IN REPLY REFER:
(ER 13/0532)

Subject: Draft Environmental Impact Statement (DEIS), National Aeronautics and Space Administration (NASA), Proposed Demolition and Environmental Cleanup Activities for the NASA administered portion of the Santa Susana Field Laboratory (SSFL), Ventura County, California.

NPS Figure 1. Regional Map of SSFL Parkland and Open Space Context

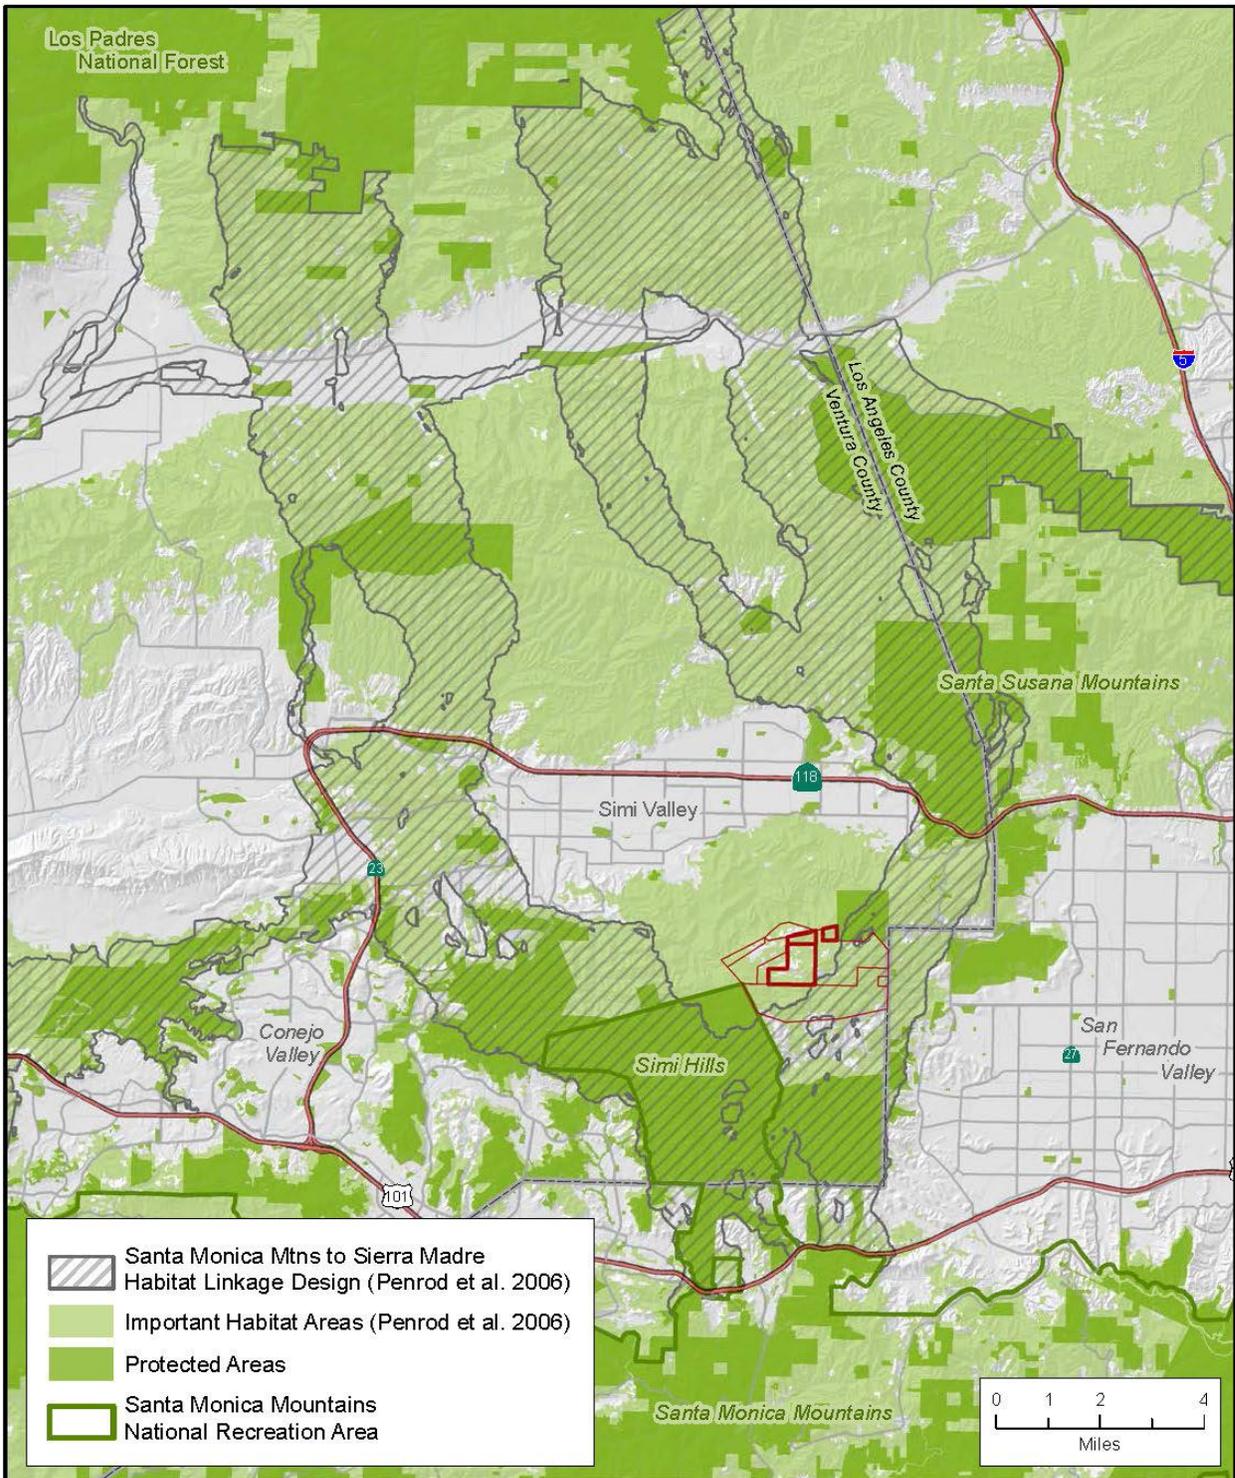
There is no regional vicinity map to illustrate the contextual setting of SSFL and the NASA portion among protected parkland, open space, and surrounding communities. The attached Figure 1 clearly illustrates the nexus of the proposed Project site and the surrounding regional parkland and open space setting. Maps in the Affected Environment and Appendices D and E either have no parkland identification or are missing several areas of public park land and protected open space. None of the maps includes the NPS-SMMNRA boundary. The SMMNRA boundary is shared with the southwestern boundary of SSFL. As noted previously, SSFL is ecologically continuous with the NPS-administered SMMNRA. The prehistoric archaeological sites are also connected to the greater prehistory and Native American cultural heritage of the Simi Hills and Santa Monica Mountains. It is critical to illustrate the parkland setting to more accurately disclose the project's potential for impacts to natural and cultural resources beyond the boundaries of SSFL and the NASA portion and to more fully disclose the site's current and potential future role in the region's ecology and recreation.

13.	Biological Resources Affected Environment Wildlife “Migration” Corridors Section 3.4.2	Figure 3.4-2 illustrates the habitat linkage area, but lacks habitat quality information and does not show park land and open space in the vicinity of the property. Thus, the figure does not adequately illustrate the location of this property in the context of existing parkland and important habitat. Please see attached NPS Figure 1 for a more accurate illustration of the greater park land and open space setting.
